AGENDA ITEM SUMMARY / STAFF REPORT
FLORENCE PLANNING COMMISSION

ITEM TITLE: PC 24 35 DR 11 –*Heceta RV Park Expansion*

PLANNING COMMISSION
 Staff report and recommendation
 for
 Design Review PC 24 35 DR 11

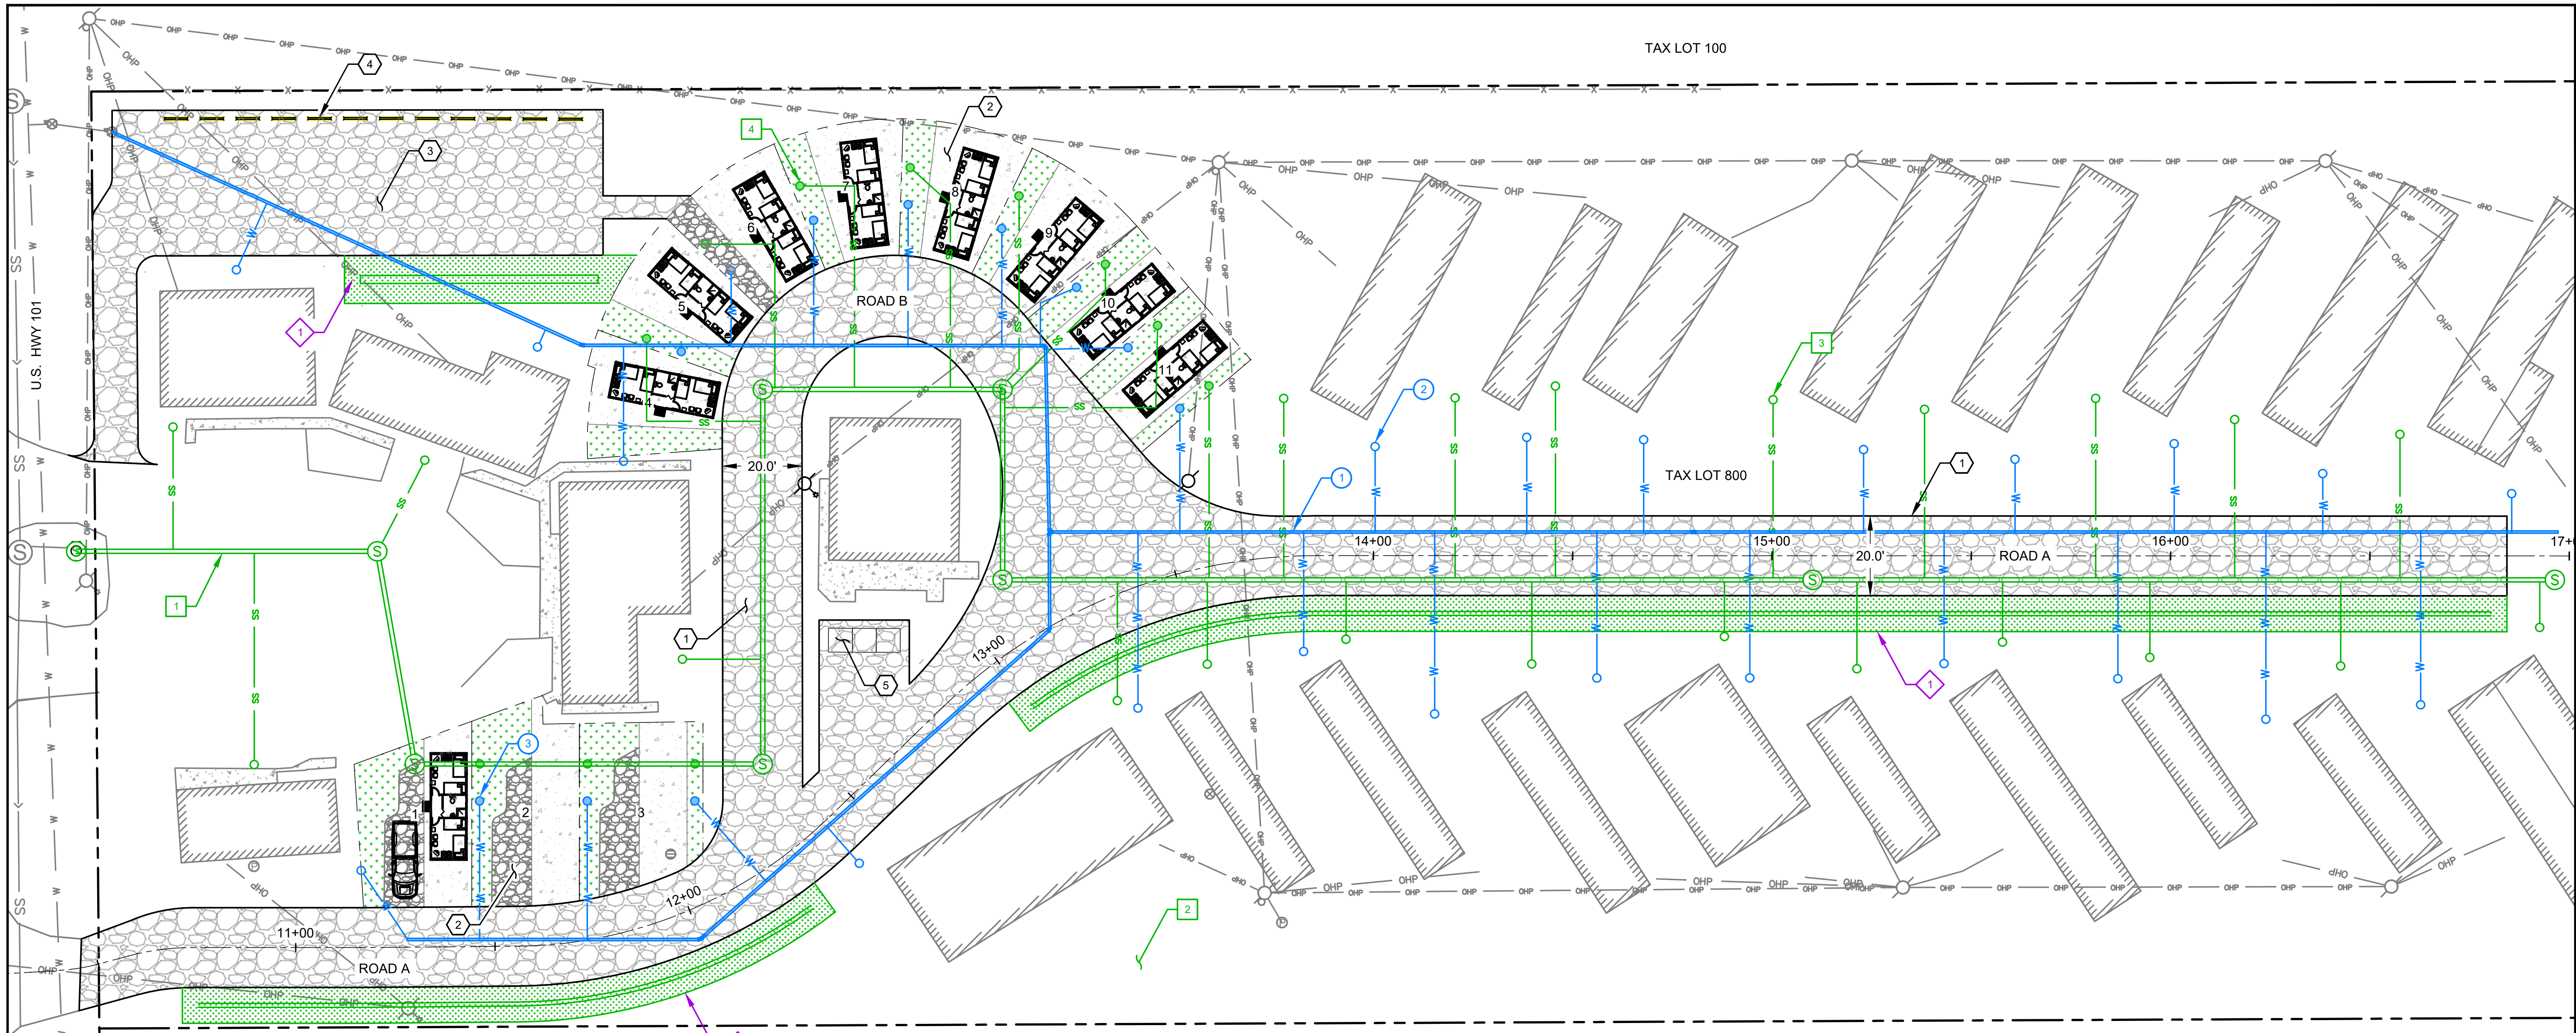
Findings: According to Table 10-3-1-B, the minimum required parking for mobile home/manufactured home parks is two spaces per mobile home plus one space for every four mobile homes. The applicants' submitted site plan shows eleven new RV spaces for residential use. Based on the above criteria, this new development would require twenty-four spots. The applicant currently proposes fifteen new parking spaces, leaving a deficit of nine parking spaces. A condition of approval will be applied to ensure the nine missing parking spaces are accounted for.

Findings: The proposed width of the 12 parking stalls in the northwest corner are denoted as 9’ x 20’ on sheet G-04. The width does not meet the above criteria. In addition, no striping is shown on the proposed plan. A condition of approval ensuring the above standards are met shall be included.

Conclusion: The proposed amount of 15 parking spaces does not meet the minimum 24 parking spaces required by the code. [The applicant shall provide 24 new parking spaces for the site, an addition of 9 from what was proposed.](#)
